## PCN

### Change of packaging for EPCOS PQ 35/35 ferrite cores

<b>1. ID No.:</b> MAG-515020718		<b>2. Date of announcement:</b> July 13, 2018	
<b>3. Product / product group:</b> EPCOS ferrite cores PQ 35/35	<b>Old ordering code:</b> B65881A0000R049	<b>New ordering code:</b> No change	<b>Customer part number:</b> No change
	B65881A0160A049		
	B65881A0000R087		
	B65881A0000R092		
	B65881A0000R095		
	B65881A0000R097		
<b>4. Description of change:</b> Change of EPS tray packaging: New packaging: EPS tray V885 with separate cavity for each core. Total height = 45 mm (see enclosure). Old packaging: EPS tray V449 with 4 cores per cavity. Total height = 30 mm.			
<b>5. Effect on the product or for the customer (benefit, quality, specification, lead time):</b> The separate cavity for each core prevent any contact between the cores and therefore chipping at the edges of the cores.			
<b>6. Quality assurance measures / risk assessment:</b> Drop tests have been performed. Packing has been approved internally.

**Enclosure** PCN (ID No. MAG-515020718)  
Dimensional drawing of new EPS tray

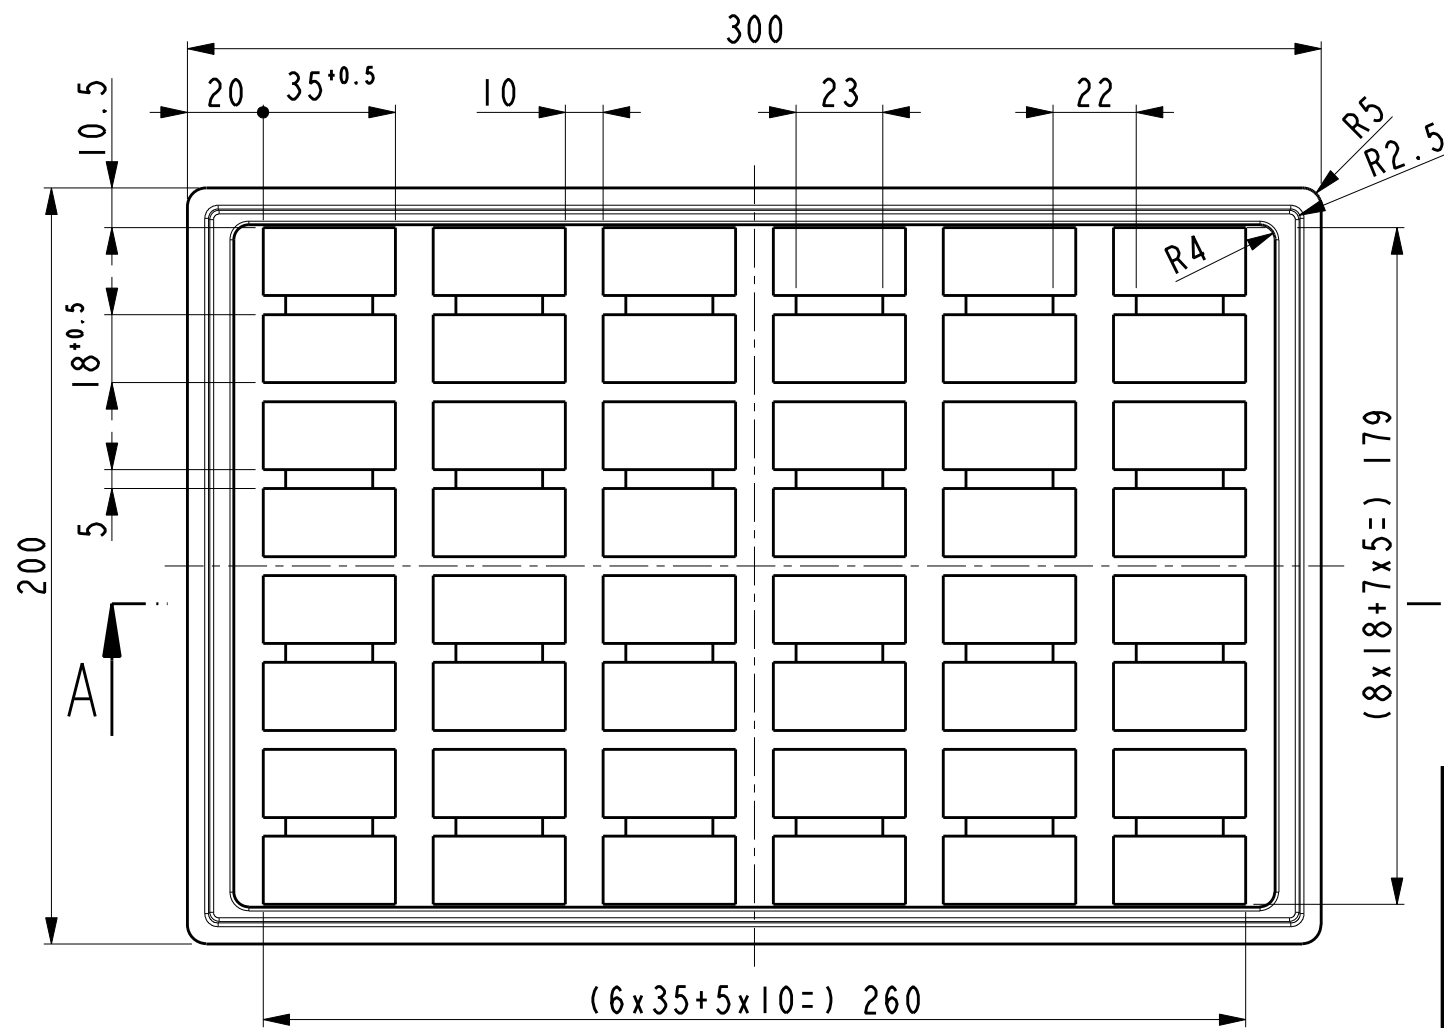
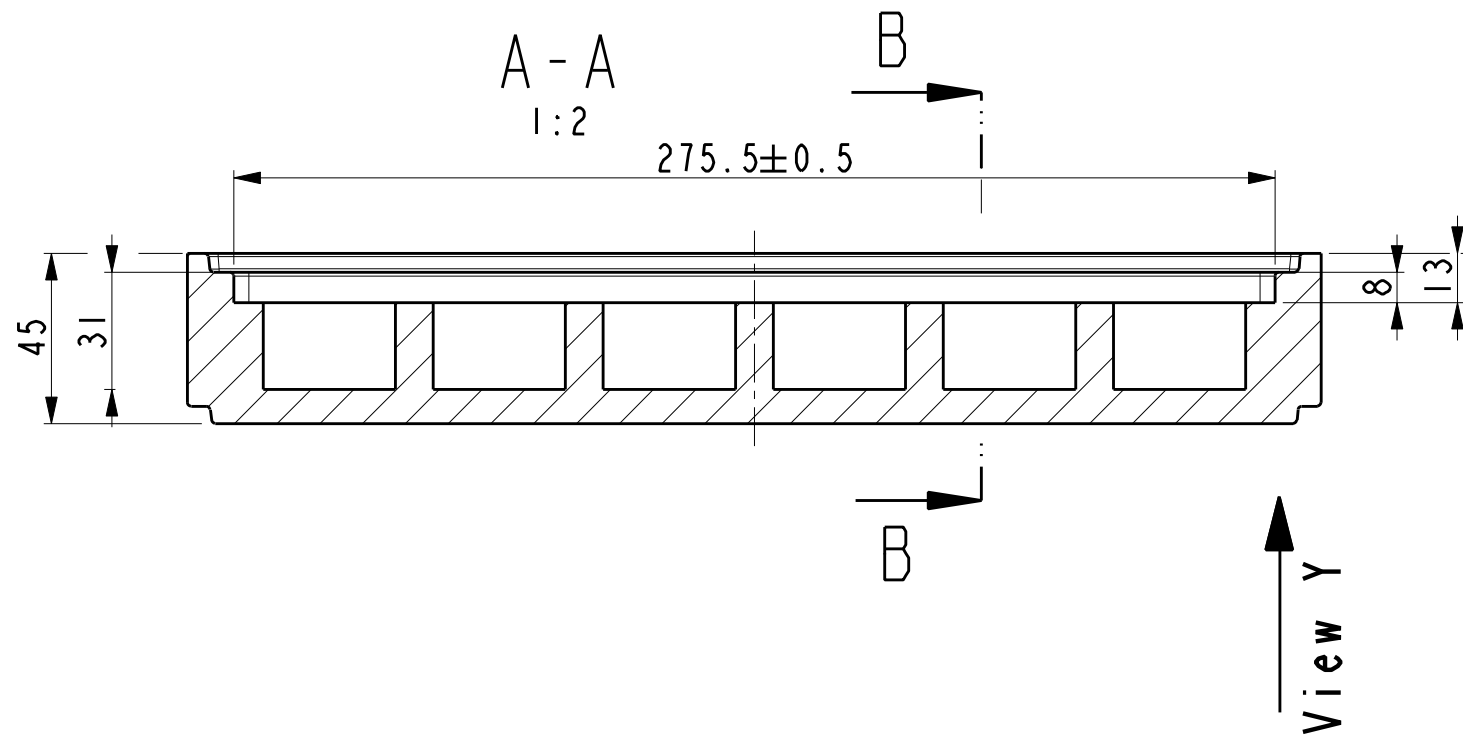
A new EPS tray packaging with separate cavity for each core is being introduced for EPCOS PQ 35/35 ferrite cores in order to prevent any contact between the cores and therefore chipping at the edges of the cores. There is no change on the product itself.
